South Texas Project
Units 1 and 2
Docket Nos. STN 50-498, STN 50-499
Responses to DSER/FSAR Items
Regarding Pipe Break Analysis

Further clarification concerning break exclusion zone criteria, which is pertinent to DSER item 3.6-1, are contained in the attached markups of FSAR pages which will be incorporated in a future FSAR amendment. The Additional revisions enclosed reflect the elimination of arbitrary intermediate breaks (AIB's) including the feedwater system AIB's.

Attachment 1

POSTULATED BREAK POINTS AND
RESTRAINT LOCATIONS
MAIN STEAM LOOP 1
30" MS 1001 GA2
Sheet 1A

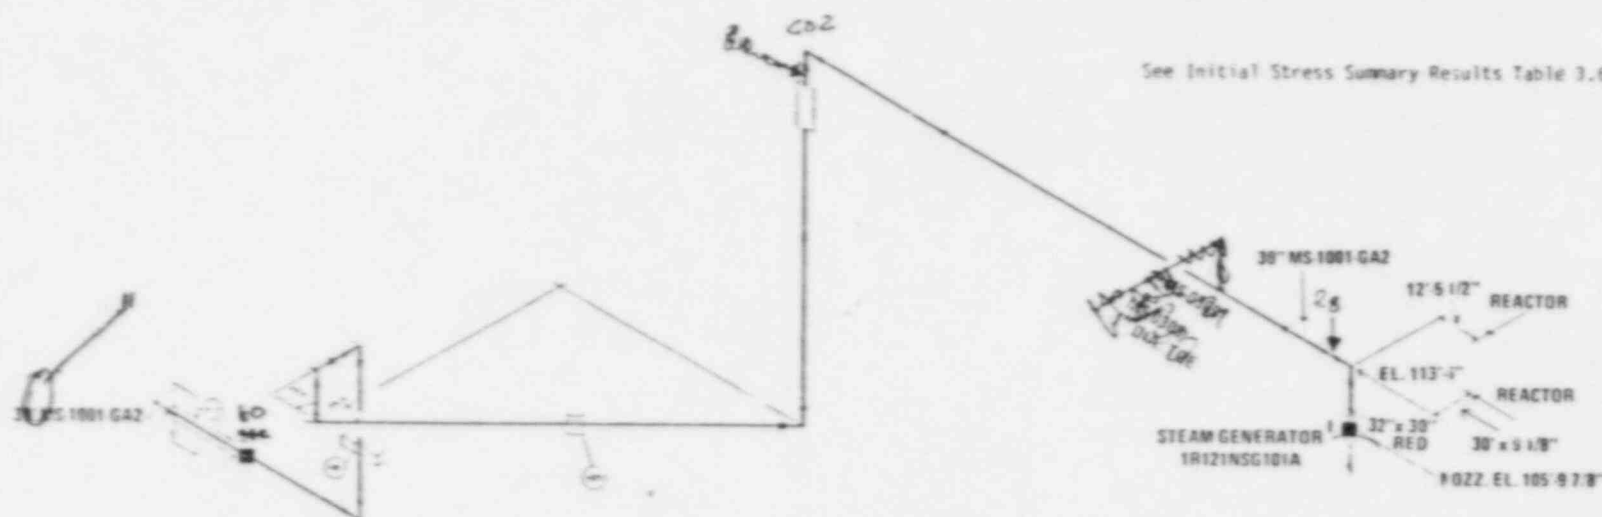
See Initial Stress Summary Results Table 3.6.2-1, SH 1A

POSTULATED BREAK POINTS AND
RESTRAINT LOCATIONS
MAIN STEAM LOOP 3
30" MS 1003 GAZ
Sheet 1C

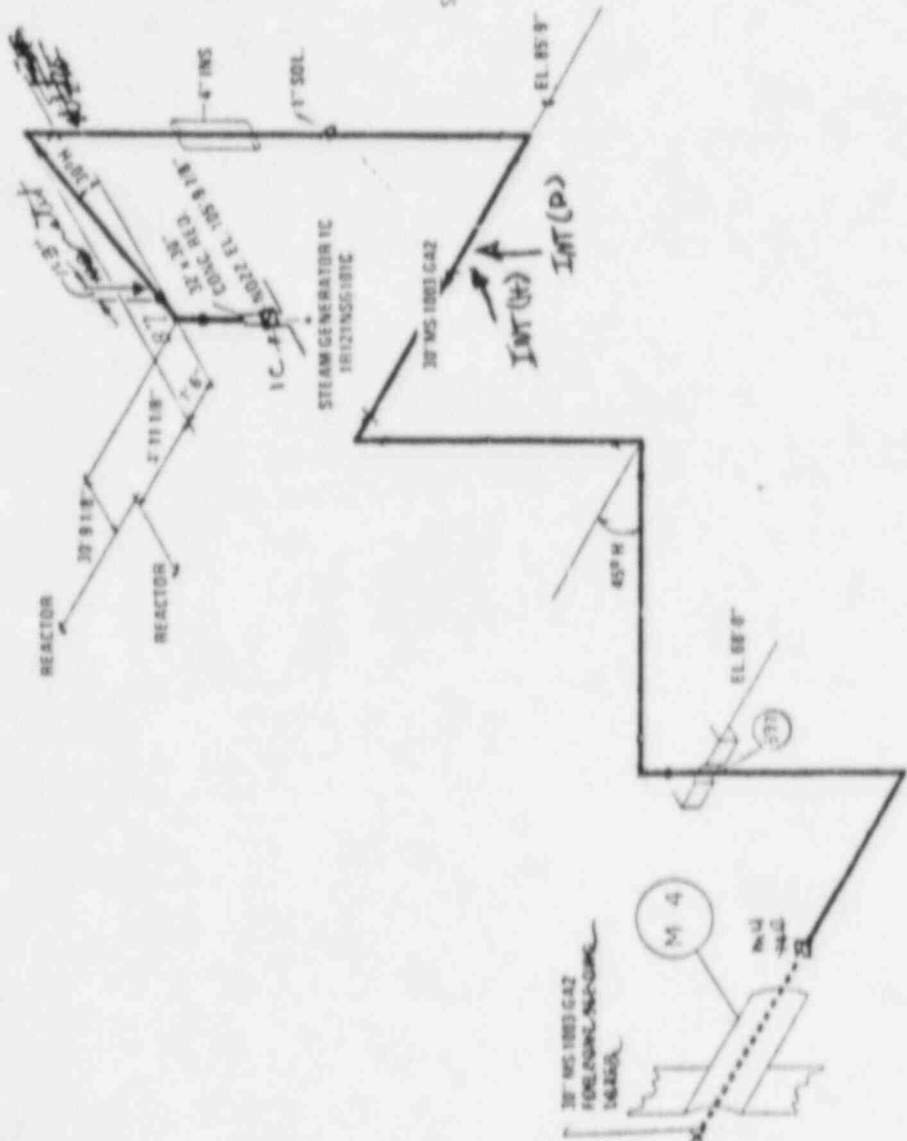
See Initial Stress Summary Results Table 3.6.2-1, SH 1C

POSTULATED BREAK POINTS AND
RESTRAINT LOCATIONS
MAIN STEAM LOOP 4
30" MS 1004 GAZ
Sheet 10

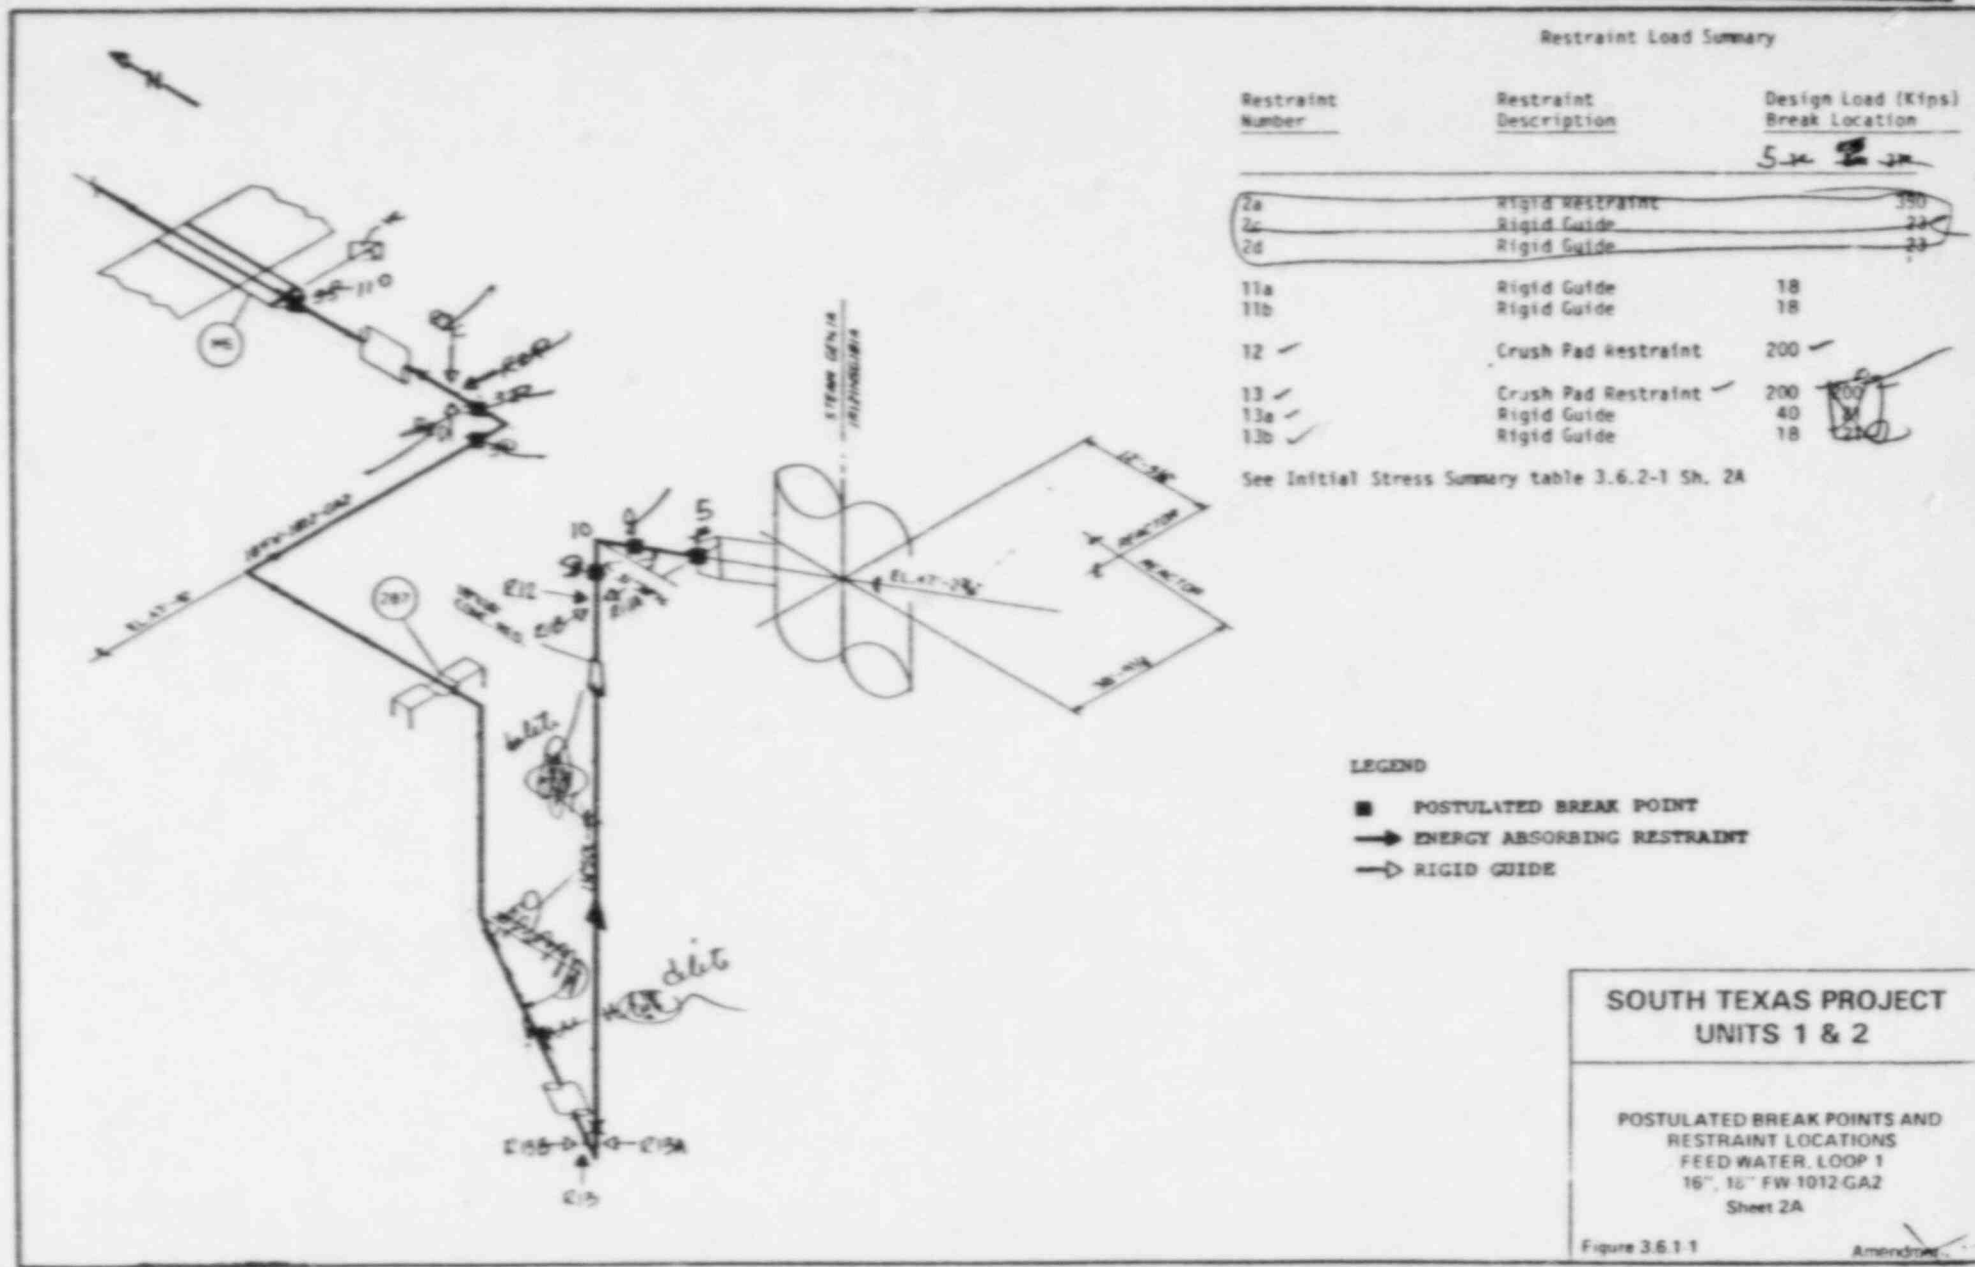
See Initial Stress Summary Results Table 2.5.2-1, SM 10

POSTULATED BREAK POINTS AND
RESTRAINT LOCATIONS
FEED WATER, LOOP 2
16", 18" FW 1014 GA2
Sheet 2B

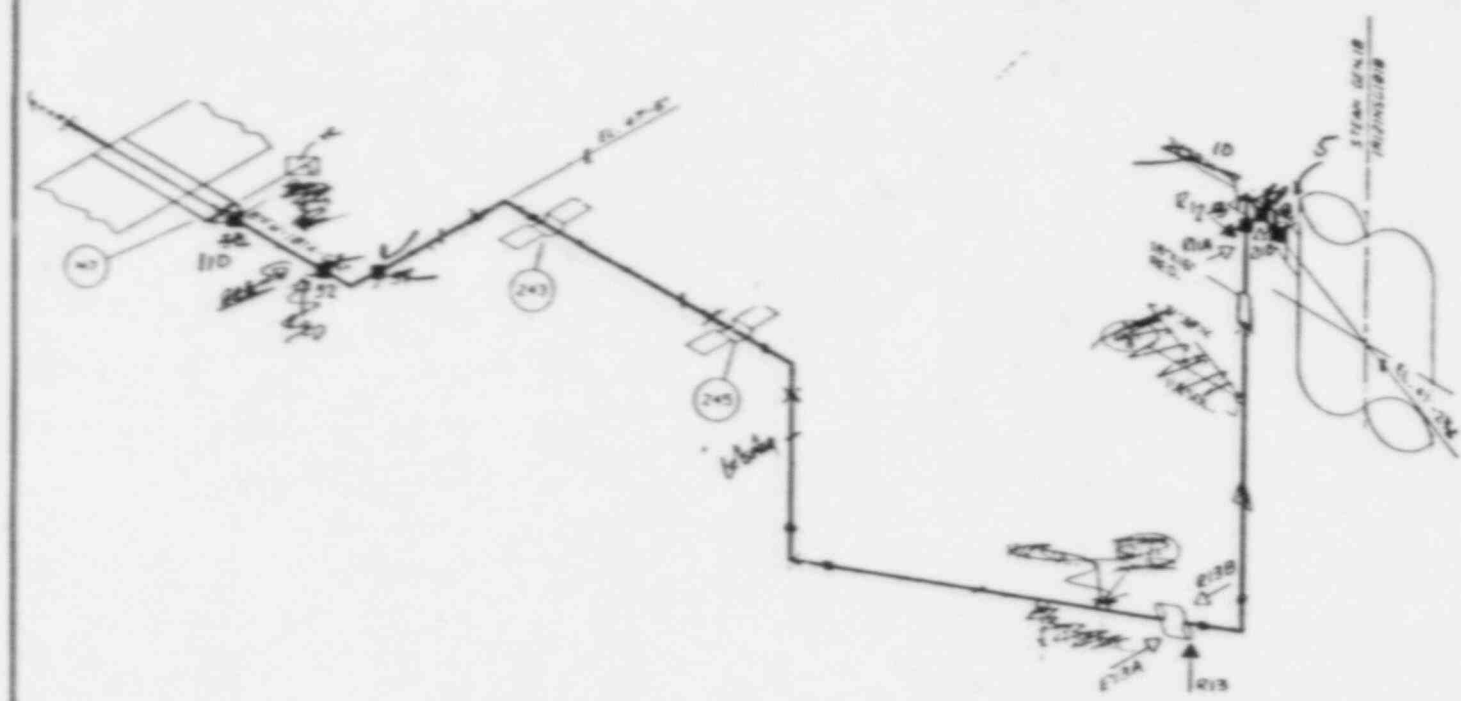
See Initial Stress Summary table 3.6.2-1 Sh. 28

POSTULATED BREAK POINTS AND
RESTRAINT LOCATIONS
FEED WATER LOOP 4
15" 18" FW 101B GA2
Sheet 20

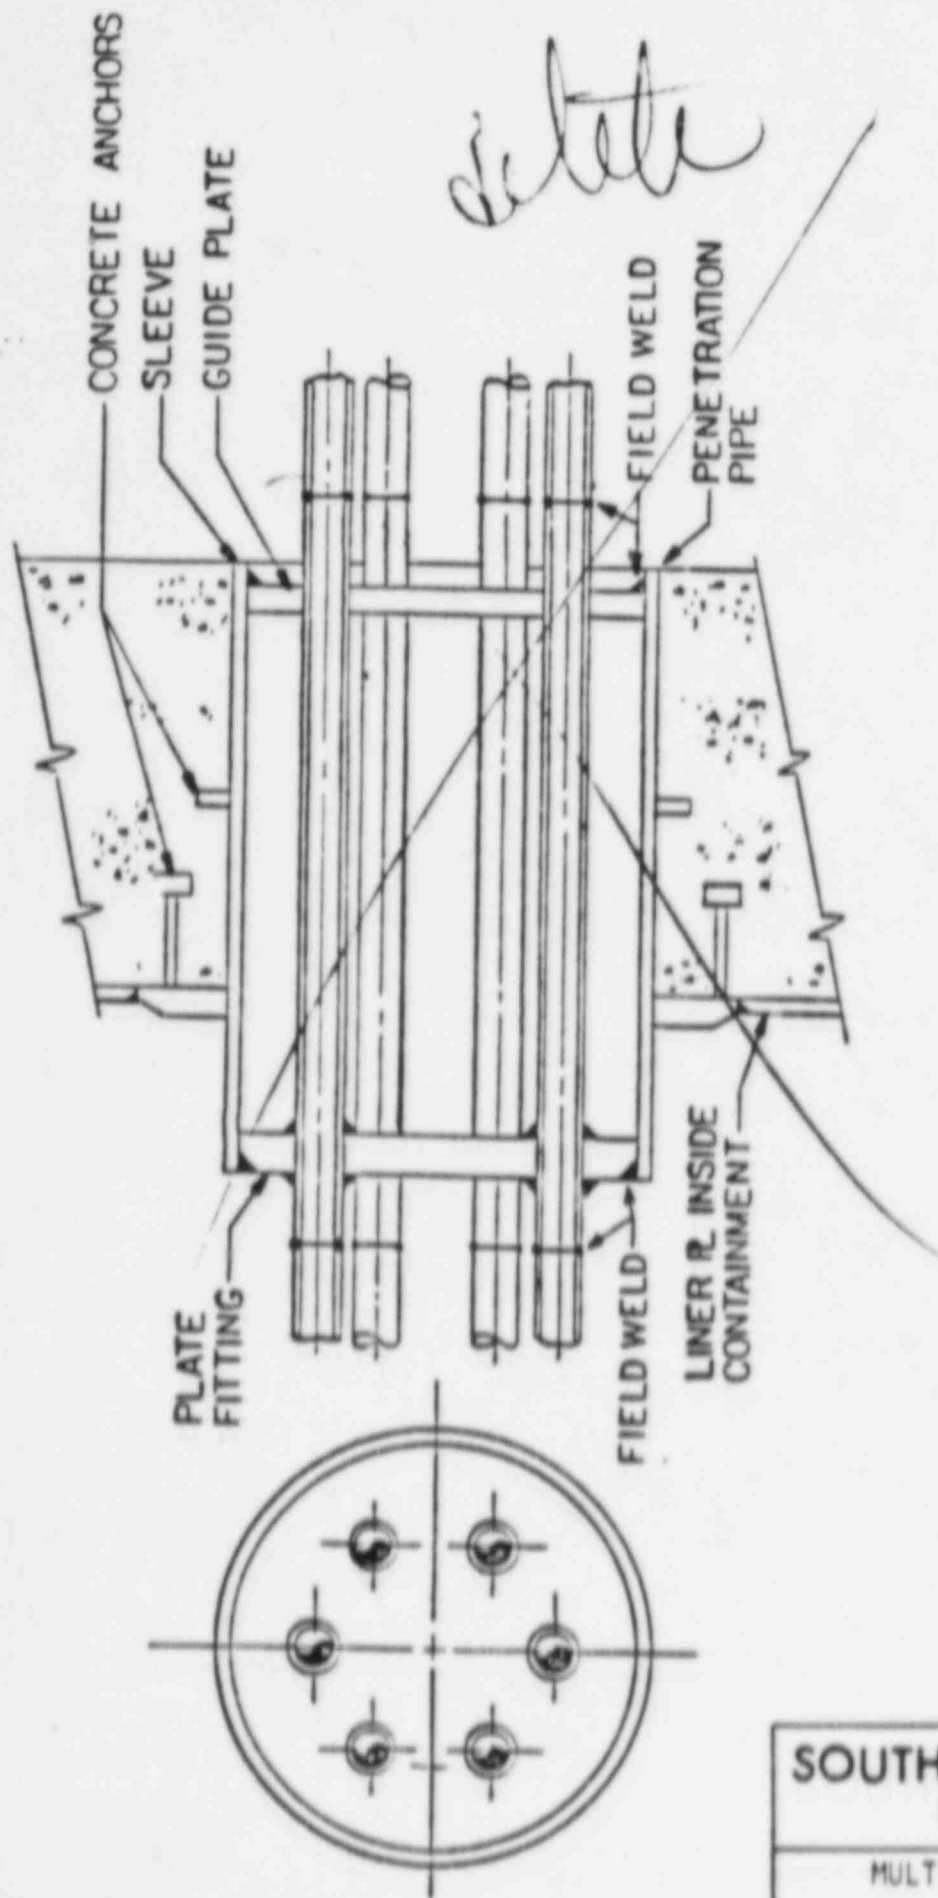
See Initial Stress Summary Table 3.6.2-1 Sh. 20

FIGURE 3.6-4

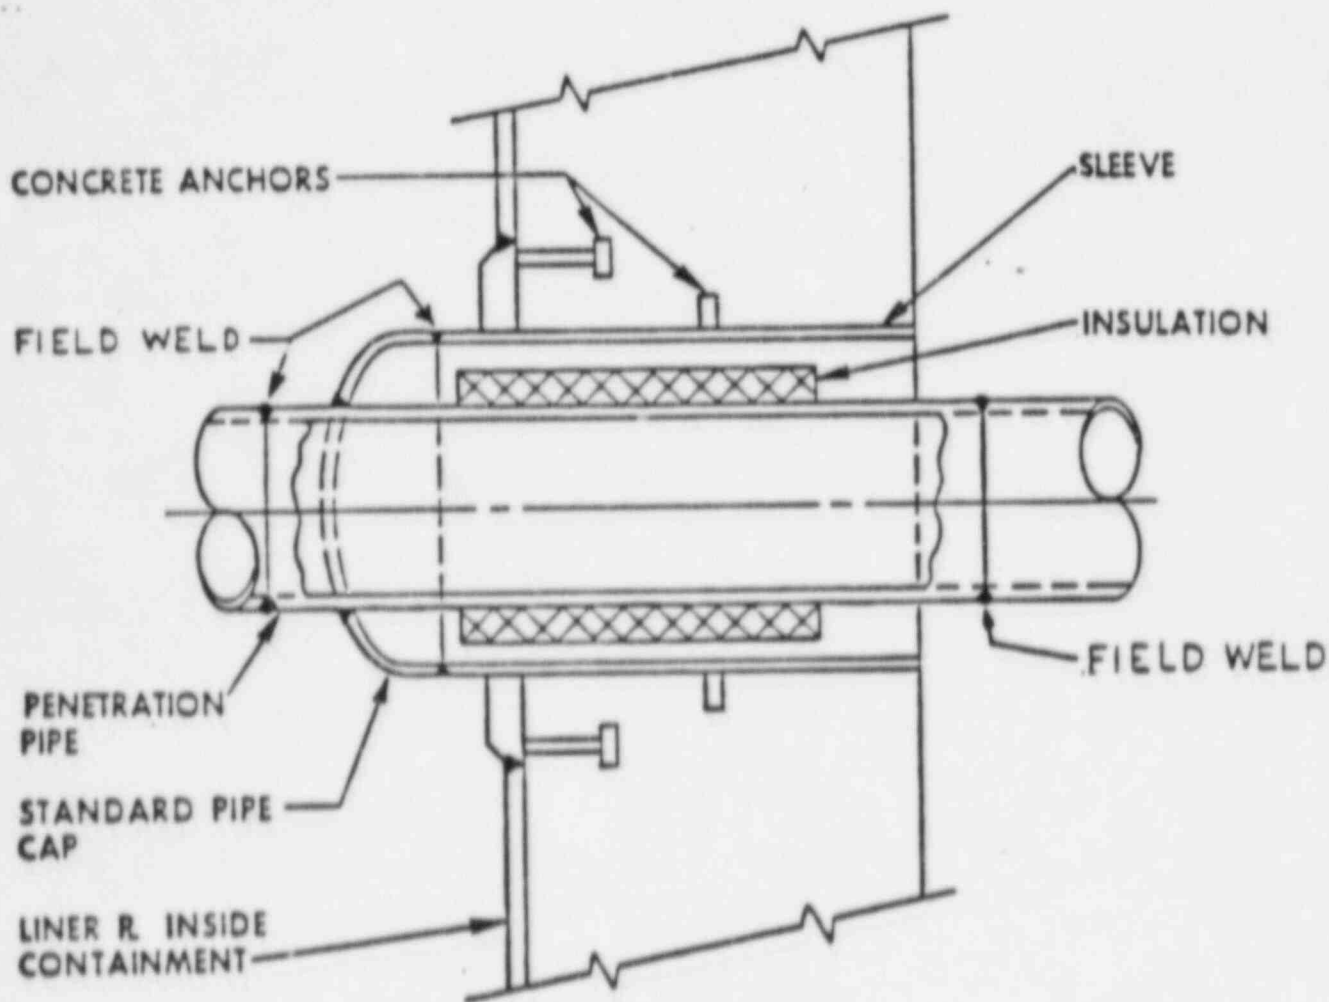
Editorial: Delete Figures 3.6-4 thru 3.6-13.

delete

FIGURE 3.6-10

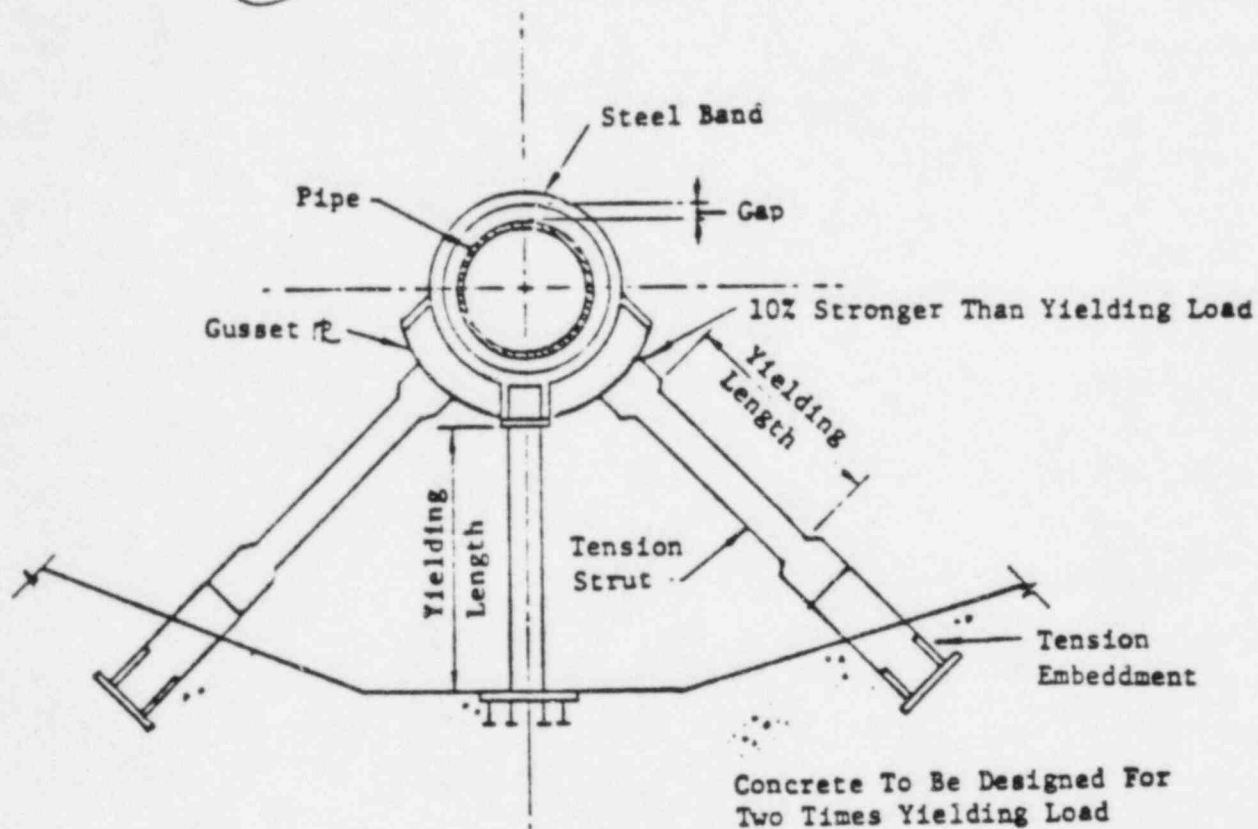
delete
